RESPONSE LETTER NO. 2 TO REQUEST FOR INFORMATION

Project Title: **Metrorail Public Address System Replacement**
Project No.: **TP-000008807**

Illustration:

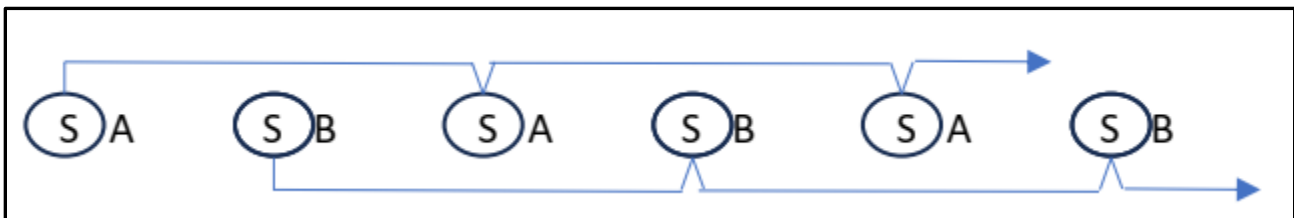
QUESTION No.10: The specs state that each speaker zone should not have more than eight (8) speakers, but makes no stipulation with regard to spacing. In similar applications it is common practice to alternate adjacent speakers into separate zones, so that if one zone should fail, that area would not lose total communication. For example, see diagram below.

ANSWER No.10: This wiring method is specified in APPENDIX A, page 21 of 66, Diagram #2.
